City of El Paso – City Plan Commission Staff Report

Case No: SUSU12-00046 Salas Subdivision Replat A
Application Type: Resubdivision Combination
CPC Hearing Date: May 31, 2012
Staff Planner: Nathaniel Baker, (915) 541-4192, bakernt@elpasotexas.gov
Location: South of Atlantic Road and East of Doniphan Drive
Acreage: 0.4 of an acre
Rep District: 8
Existing Use: Single-family homes
Existing Zoning: C-4 (Commercial) / R-5 (Residential)
Proposed Zoning: C-4 (Commercial) / R-5 (Residential)
Nearest Park: Pacific Park (1/4 mile)
Nearest School: Zach White (1 mile)
Park Fees Required: \$13,620
Impact Fee Area: N/A
Property Owner: Eutiquio Sanchez & Enrique Espalin
Applicant: Eutiquio Sanchez & Enrique Espalin
Representative: Dorado Engineering, Inc.

Salas Subdivision Replat "A"

SALAS SUBDIVISION REPLAT "A"

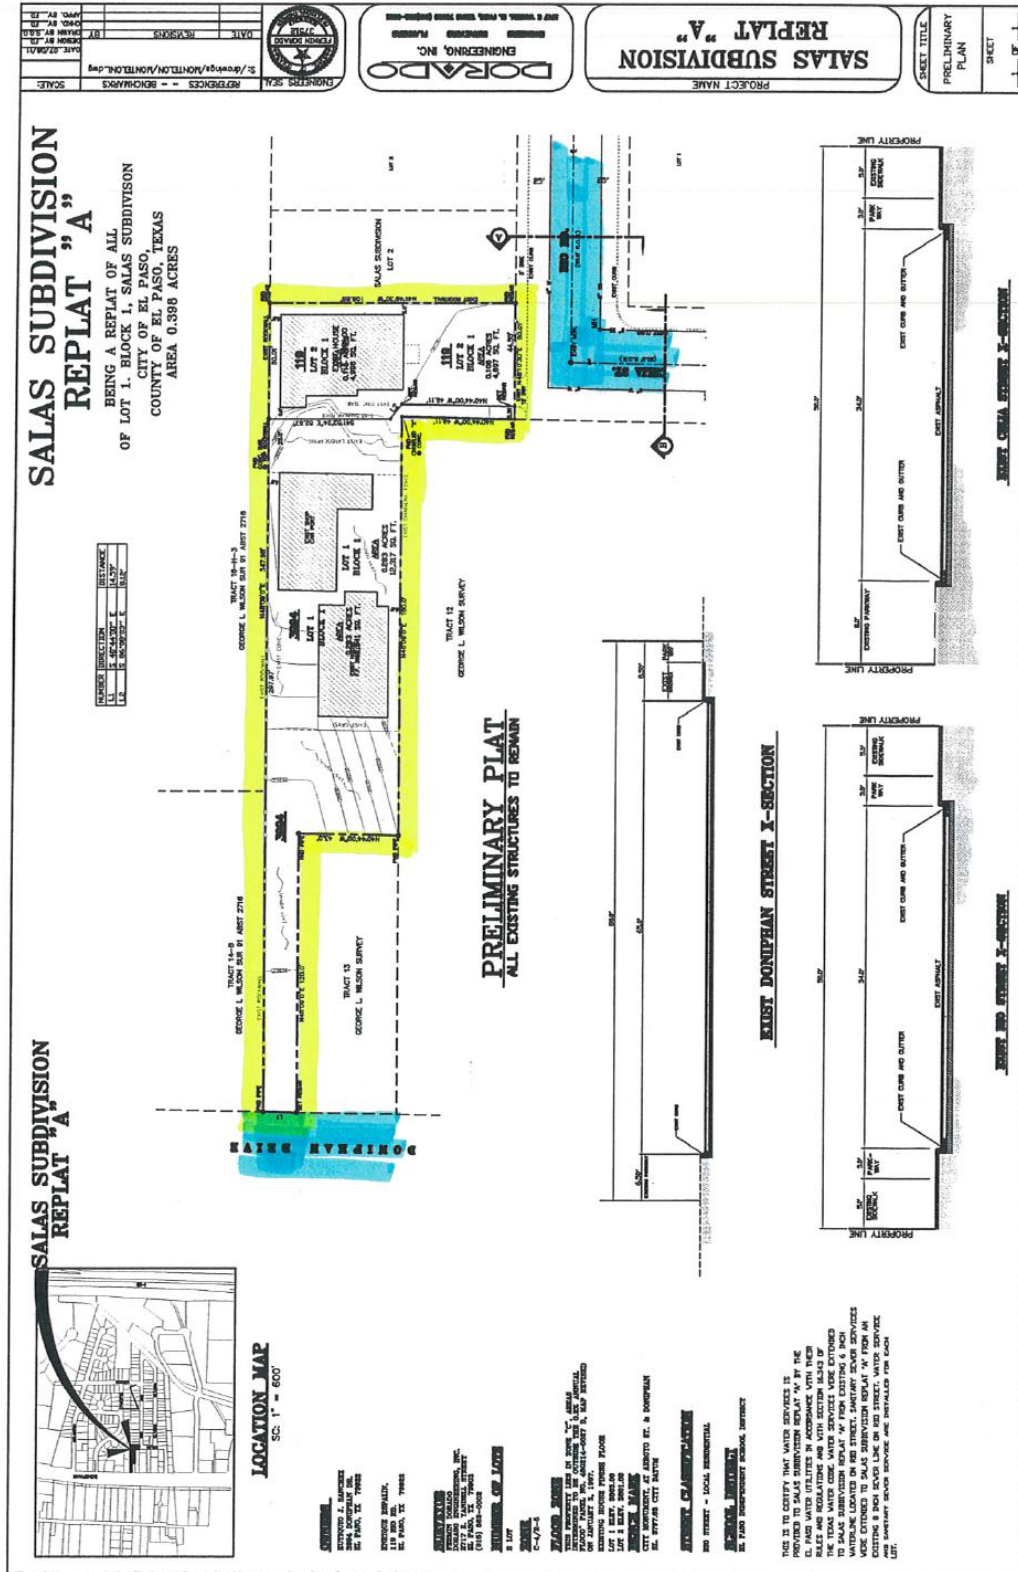
Per section 19.23.040.C, any buildings served by a panhandle in excess of 100 feet will be required by the fire marshall to be sprinklered and have a hard wired alarm system. A note shall be added to the recording plat and the subdivision improvement plans indicating buildings are required to be sprinklered within the subdivision, and which lot numbers have such requirements.

Place a note on both plats stating that Private Drainage Easement is required if the Lots are further subdivided.

1. The panhandle of Lot 1 Block 1 does not comply with Section 19.23.040.C (Flag or Panhandle Lots) as the panhandle exceeds 100 feet in length for either a residential or commercial development.
2. Provide the turning heel of Rio Road at Celia Street.
3. If commercial development, the proposed 12 ft. driveway on Lot 2 Block 1 does not comply with the commercial/industrial driveway design standards. Clarify if the subdivision is commercial or residential.
4. The existing cross-sections for Doniphan Drive, Rio Road, and Celia Street do not comply with Section 19.15.110 (Street Width and Design).
 - The proposed subdivision complies with the waiver requirements of Section 19.10.050.A.1.a (Roadway Participation) which allows for a waiver of improvements required to bring Doniphan Drive, Rio Road, and Celia Street up to current development standards.

1. The double frontage lot along Doniphan Drive shall comply with Section 19.23.040 (Double frontage lots).
 2. Access and improvements to Doniphan shall be coordinated and approved by TxDOT.
- All existing / proposed paths of travel (accessible sidewalks, wheelchair access curb ramps and driveways) within public rights-of-way shall be in compliance with current ADA/TAS rules and regulations and the current City of El Paso Design Standards for Construction.
